# EPSON PRODUCT SUPPORT BULLETIN

<b>Date:</b>	04/20/2009	<b>Originator:</b>	JAM
<b>PSB #:</b>	PSB.2009.06.001	<b>Authorization:</b>	<i>Kas</i>
<b>Reference:</b>	TI 09-05e Rev. A/B	<b>Total Pages:</b>	5
<b>Product(s):</b>	PowerLite 735c / Cinema 500 / 737c / 745c / 755c / 765c / 830p / 835p / 1705c / 1715c / 6100i / 6110i / 7800p / 7850p / 7900NL / 8300i / 8300i with EasyMP.net module / 9300NL / 1815p / 1825 / 822p / 83c / 822+ / 83+ / G5000 / Pro G5150 / Pro G5350 / Pro G5200W / 1725 / 1735W / 400W / 410W / 84 / 85 / 825 / 826W PowerLite 61p / 81p / 82c / 821p / 1810 / 260d (Latin America) / 280d (Latin America) with TCP/IP to Serial converter		
<b>Subject:</b>	Release of EMP Monitor for Windows version 4.30

<b>Date:</b>	11/13/2007	<b>Originator:</b>	AP
<b>PSB #:</b>	PSB.2007.11.005A	<b>Authorization:</b>	Kas
<b>Reference:</b>	TI 07-63e, Rev. A	<b>Total Pages:</b>	3
<b>Product(s):</b>	Epson EMP Monitor		
<b>Subject:</b>	EMP Monitor Version 4.21 Release

<b>Date:</b>	8/30/2007	<b>Originator:</b>	DS
<b>PSB #:</b>	PSB.2007.08.001	<b>Authorization:</b>	<i>Kps</i>
<b>Reference:</b>	N/A	<b>Total Pages:</b>	1
<b>Product(s):</b>	Epson Projectors with an HD-15 VGA Analog/Component Input

EMP Monitor V4.30

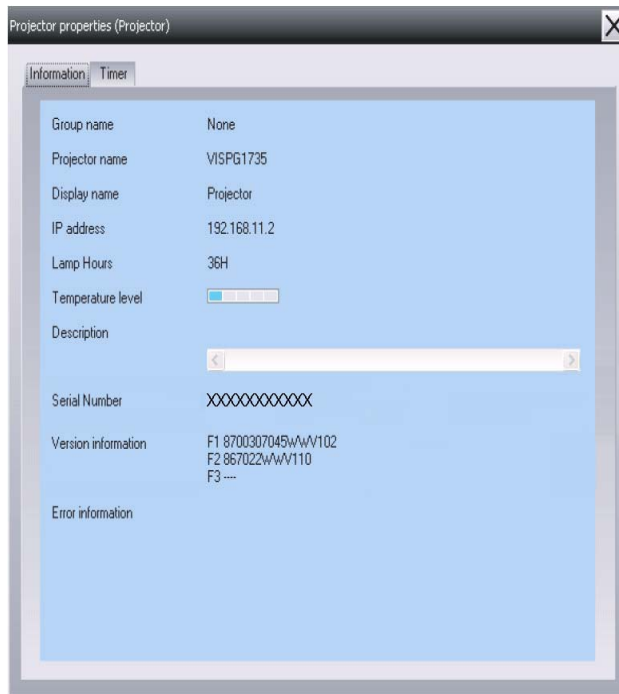
(2) Addition of Input Source (Only PowerLite 84 / 85 / 825 / 826W)  
Previous version of EMP Monitor included USB Display, USB and LAN as one source: EasyMP.

The input source buttons for USB display, USB, and LAN are available as separate input sources as shown below:
